**RE: LU-24-027 Conditional Use Permit Application Regarding Landfill Expansion**

## **Annex 1**

### **Deficiencies in the Applicant's Analysis of Hydrogeological and Seismic Impacts of Landfill Construction and Operation**

Figure 1. Arsenic concentrations in wells on the east side of Coffin Butte Landfill (from p. 245 of the 2023 Annual Environmental Monitoring Report submitted to Oregon DEQ).

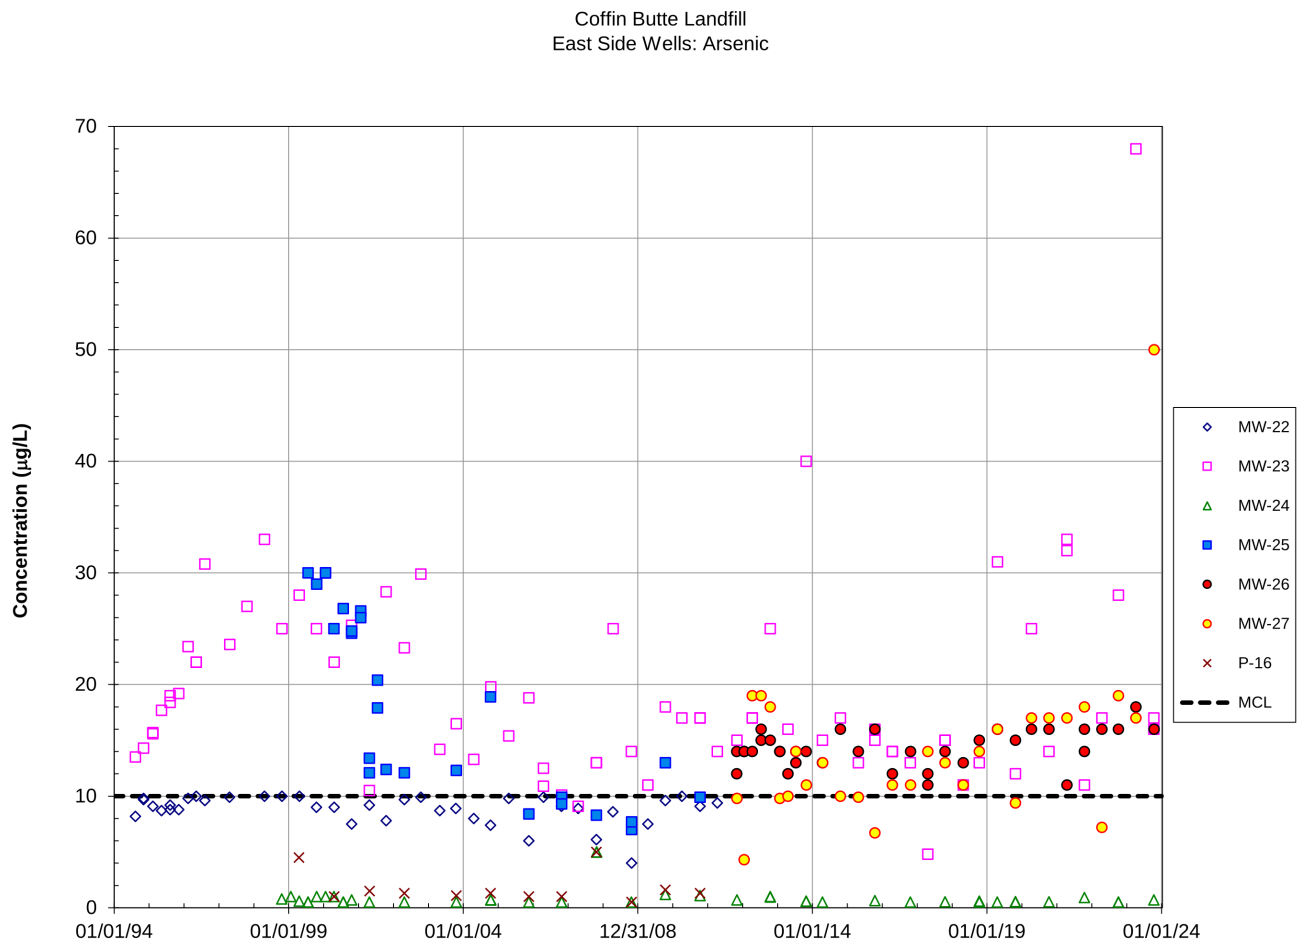
This statement has two parts. The second part cannot be evaluated because neither the applicant nor Oregon DEQ nor Benton County have tested for potential impacts of leachate on the environment, anywhere outside of the site boundary. This despite that two of the compliance boundary wells (MW-26 and MW-27) have registered arsenic concentrations above the US EPA's maximum contaminant level (MCL) regularly for the past 14 years (Figure 1).

From Figure 1 it can be seen that, after a few years of decline following measures to address the seepage problem, arsenic levels in MW-23 (see Figure 3 for well locations) have continued to fluctuate over a wide range, spiking several times to levels above 30 micrograms per liter.

The compliance boundary wells (MW-26 and MW-27) have exceeded the US EPA's MCL for arsenic in most measurements since they were installed. Most arsenic measurements in both of these compliance-boundary wells are also higher than in any wells not on the landfill site, within the Analysis Area chosen by the applicant.

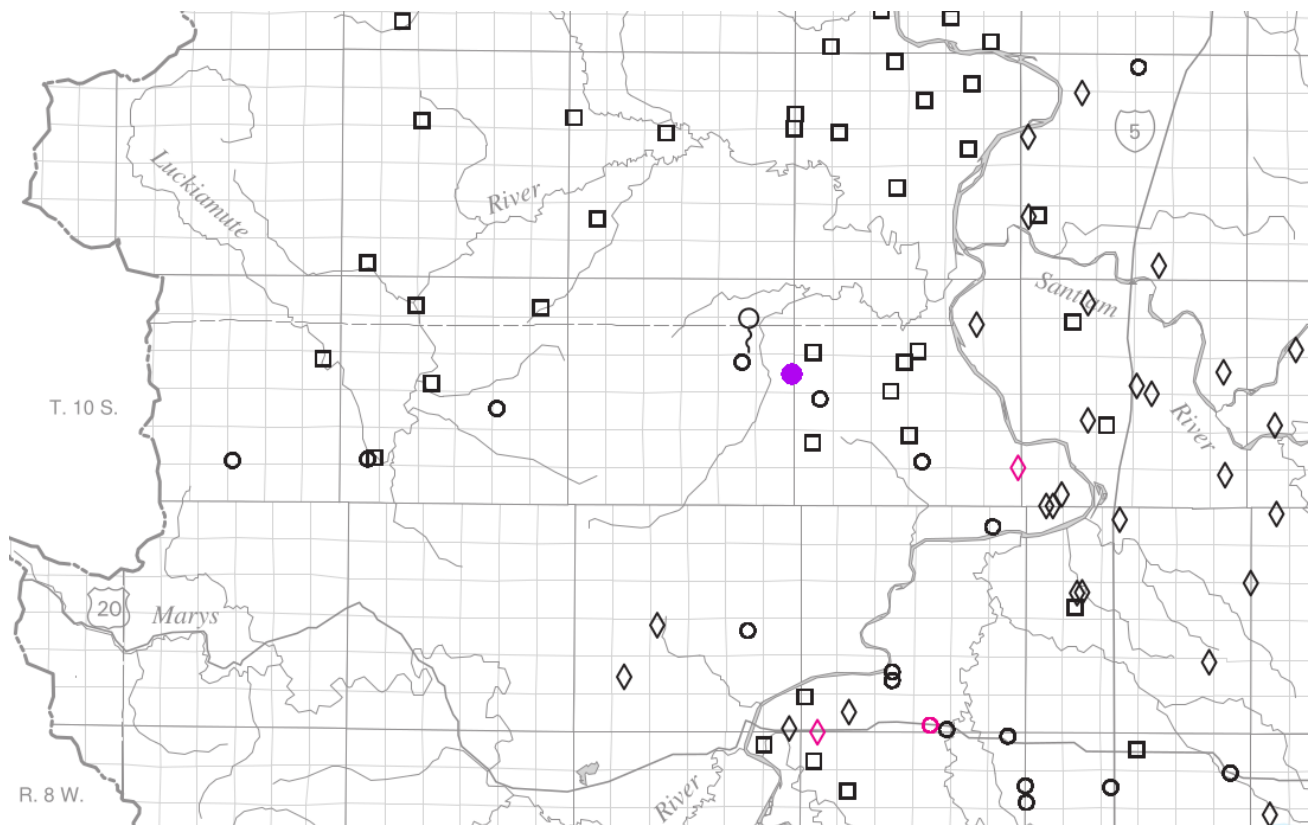
However a regional study data by US Geological Survey scientists, published in 1999,<sup>1</sup> shows clearly that the values observed at Coffin Butte are highly unusual for northwestern Benton County and adjoining areas of Polk County (see Figure 2).

Values higher than the US EPA's maximum contaminant level (MCL) of 10 micrograms per liter are rare (just 3 wells out of more than 80 in the area of this detail, none of them within the applicant's Analysis Area). None of the wells evaluated by Hinkle and Pollette (1999) were found to have arsenic concentrations above 50 micrograms per liter. In contrast, arsenic concentrations in two wells at the Coffin Butte Landfill site have recently risen to 50 micrograms per liter and 68 micrograms per liter, respectively.<sup>2</sup>

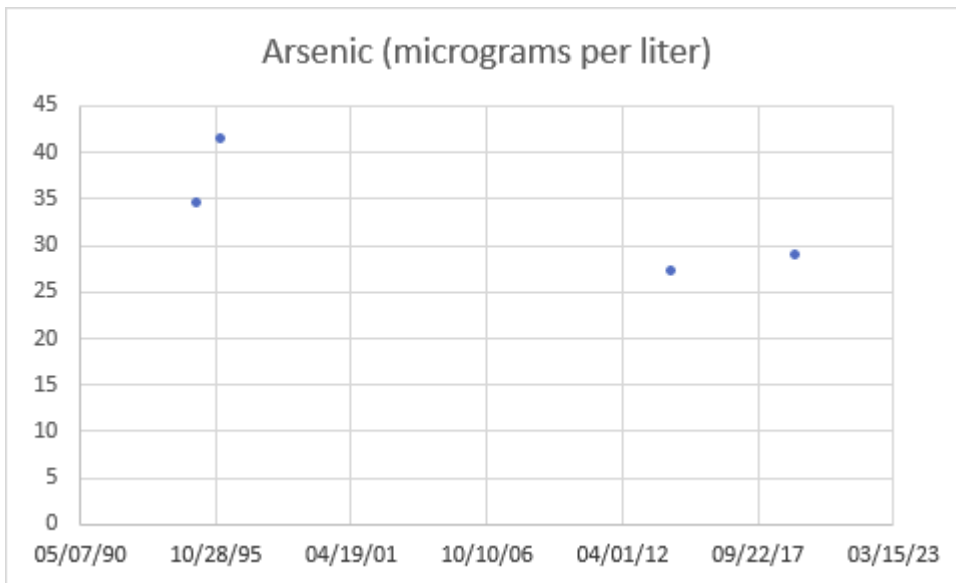
Indeed, the available data from MW-9S (Figure 4) show that measurements shortly after the seepage problem was discovered in 1994 were higher (35 to 42 micrograms per liter) than the values seen since 2014 (in the range 27 to 29 micrograms per liter). This is consistent with the idea that this well could have initially been contaminated by leachate (which has arsenic concentrations above 100 micrograms per liter) arriving relatively directly via surface drainage, but since has declined to levels more consistent with a groundwater plume.

In any case, concentrations observed in MW-23 and the compliance-boundary well MW-27 in 2023 exceeded the highest concentrations ever measured in MW-9S.

So even if we accept the applicant's questionable claim that MW-9S represents "baseline," recent measurements have exceeded the supposed baseline values.
